Development Special Use Permit #2010-0004 3100 Jefferson Davis Highway – Marino's Restaurant

Application	General Data		
Project Name: Marino's Restaurant	PC Hearing:	March 1, 2011	
	CC Hearing:	March 12, 2011	
	If approved, DSUP Expiration:	March 12, 2014 (3 years)	
	Plan Acreage:	9,760 sq. ft. (0.224 acres)	
Location: 3104 Jefferson Davis Highway.	Zone:	Commercial Service Low (CSL)	
	Proposed Use:	Proposed two-story restaurant addition to	
		the existing one-story restaurant.	
	Dwelling Units:	Not applicable	
	Floor Area Ratio:	Existing: 0.09, Proposed: 0.35	
Applicant: Ather Subzwari	Small Area Plan:	Potomac West	
	Historic District:	Not applicable	
	Green Building:	Requesting Flexibility

Staff Recommendation: APPROVAL WITH CONDITIONS

<u>Site plan</u>

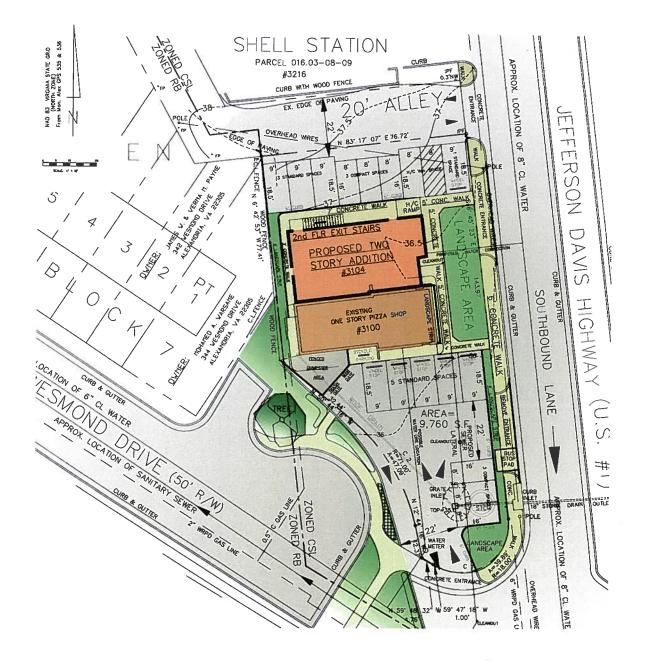
- 4. Provide the following modifications to the landscape plan and supporting drawings:
 - a. Provide verification that the rear screen planting allows for access and circulation to rear doors.

- b. Add fastigiate tree, shrub and groundcover planting to the proposed landscape area east of the building's front façade (shown in Attachment #1). Consider rain garden or infiltration bed planting in addition to ornamental planting.

- c. Add shrub or groundcover planting to the landscape area at the south of the site.
 - d. Substitute the planting material proposed for the eastern landscape strip for planting material with long-season visual interest and which is capable of low maintenance, road salt and drought conditions typical of the site's urban setting.
